PIC16C925/926 (Rev. B2 Silicon) Data Sheet Errata

The PIC16C925/926 Rev. B2 parts you have received conform functionally to the Device Data Sheet (DS39544A), except for the anomalies described below.

FIGURE 1: PORTC BLOCK DIAGRAM (PERIPHERAL OUTPUT OVERRIDE)

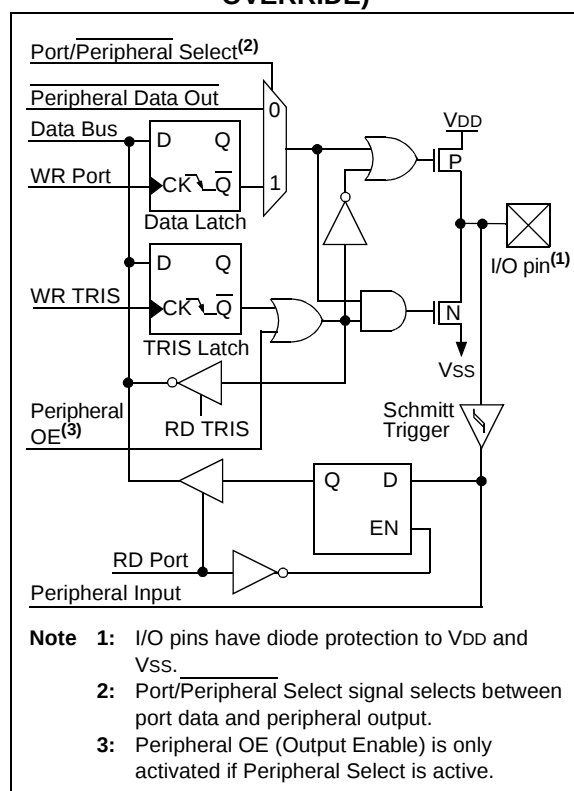
The block diagram for PORTC presented in Figure 4-5 of the Device Data Sheet (DS39544A) is incorrect. The correct block diagram is shown in Figure 1.

FIGURE 11-2: WAVEFORMS IN STATIC DRIVE

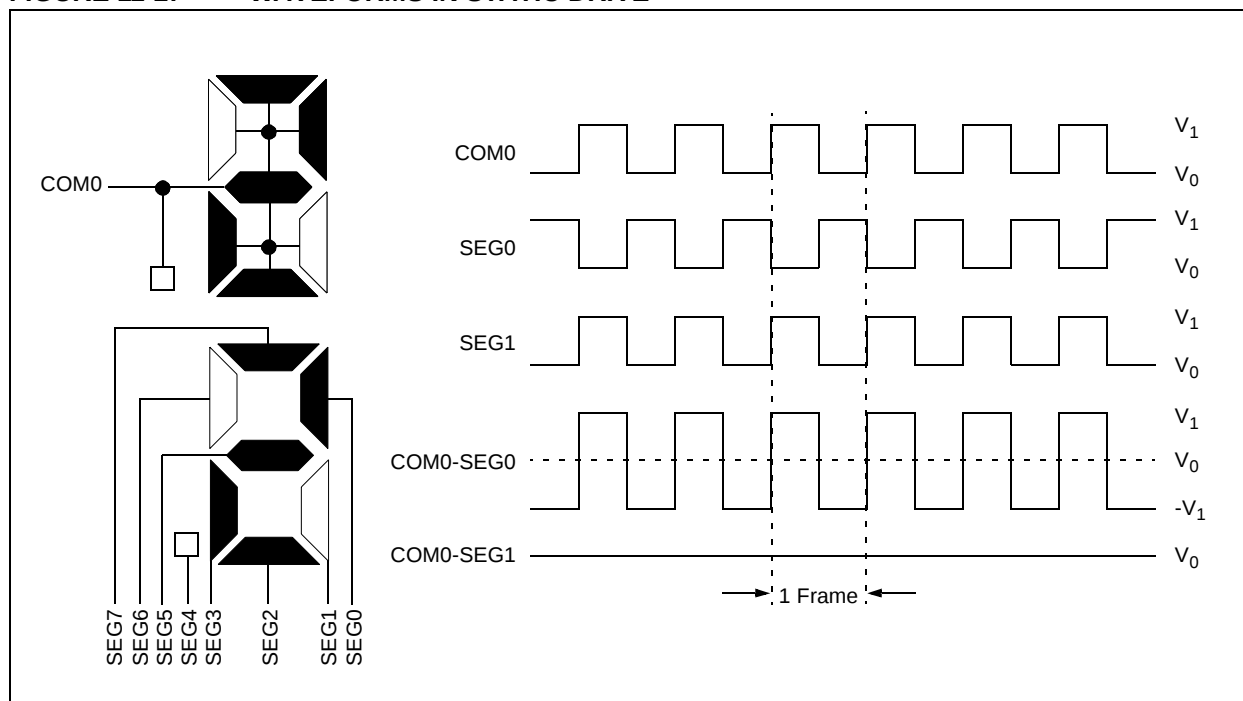
The illustrations of the LCD segment connections, their drive waveforms in various modes and their descriptive titles, have been revised. The changes have been made to make the illustrations and mode descriptions more consistent with those shown for the PIC16C923/924 family of devices in DS30444E.

The diagrams in Figure 11-2 through Figure 11-5 (below and the following pages) replace the corresponding diagrams in the Device Data Sheet (DS39544A).

FIGURE 2: ALTERNATE METHOD FOR REDUCING VARIATIONS IN VLCDADJ VOLTAGE

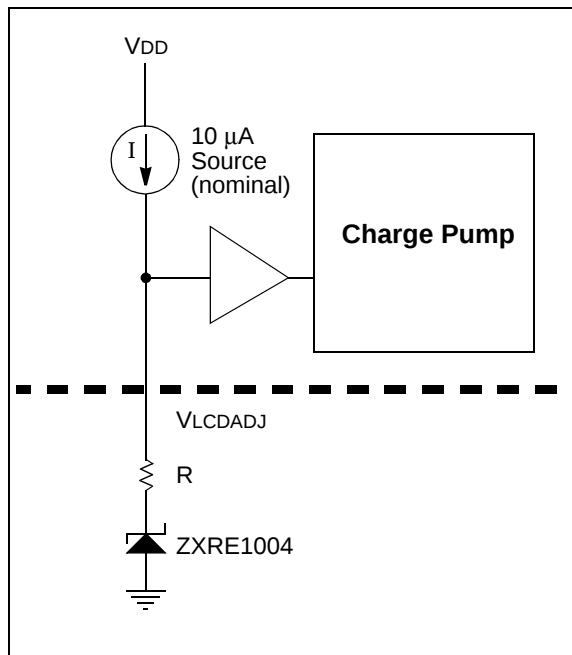
The current source associated with the LCD module charge pump has a nominal output of 10 μA (see Figure 11-9). However, current regulation within individual devices may vary from approximately 7 to 15 μA . Since this current sets up the VLCDADJ voltage, variation in this current can create noticeable LCD contrast variations when using the LCD charge pump.

To reduce the variation in the VLCDADJ voltage, without using a trim potentiometer or trim resistors (which must be manually adjusted), it is possible to use a band gap voltage reference circuit such as the 1.22V ZXRE1004 reference from Zetex, as shown in Figure 2. Resistor Rx placed in series with the band gap reference and the VLCDADJ pin can be used to set a voltage higher than the band gap reference voltage, if necessary. The voltage is determined by the formula:

$$V_{\text{LCDADJ}} = 1.22\text{V} + (I \times R)$$

As can be seen from this equation, a smaller series resistor, R, results in smaller variations in VLCDADJ voltage.
